# Access Compliance Report

## Public Rights-of-Way

### (Curb Ramps)

Intersection ID: 5124	Main Street: GIBBON_RD	Cross Street: OLD_STATESVILLE_RD	Location: S
ADA ID: 3F4D20F19D92	Ramp Type: Perp	Initial Pass/Fail: Fail	Overall Compliance: No
Severity Score: 33.75			
Codes/Mitigation Info/Possible Solution		Field Measurements/Component Compliance

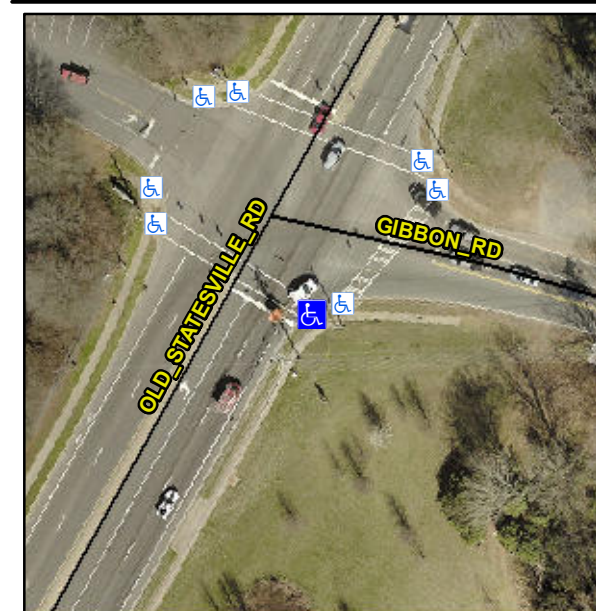
**Not Found, R304.5.1, R304.2.2**

Compliance	Description	Data	Compliance	Description	Data
N/A	Ramp Length (in)	59.0	No	Ramp Slope (%)	13.7
No	Ramp Width (in)	44.0	Yes	Ramp XSlope (%)	0.7
N/A	Flare Type LT	N/A	N/A	Flare Type RT	N/A
N/A	Flare Slope LT (%)	N/A	N/A	Flare Slope RT (%)	N/A
N/A	Flare Traversable LT?	N/A	N/A	Flare Traversable RT?	N/A
N/A	Landing Length (in)	N/A	N/A	DWS Provided?	N/A
N/A	Landing Width (in)	N/A	N/A	DWS Contrast?	N/A
N/A	Landing Slope (%)	N/A	N/A	DWS Length (in)	N/A
N/A	Landing X Slope (%)	N/A	N/A	DWS Full Width?	N/A
N/A	Landing Curb? (Y/N)	N/A	N/A	DWS Offset (in)	N/A
N/A	Shared Landing?	N/A			
N/A	Gutter Ponding?	N/A	N/A	Gutter Slope (%)	N/A
N/A	Gutter Lip Ht (in)	N/A	N/A	Gutter X Slope (%)	N/A
N/A	Painted X Walk1?	Yes	N/A	Painted X Walk2?	N/A
	X Walk 1 Direction	To NW		X Walk 2 Direction	N/A
N/A	X Walk 1 Width (in)	111.0	N/A	X Walk 2 Width (in)	N/A
	X Walk 1 Slope (%)	1.3		X Walk 2 Slope (%)	N/A
	X Walk 1 X Slope (%)	1.3		X Walk 2 X Slope (%)	N/A

**Remove & Replace Entire Ramp.**
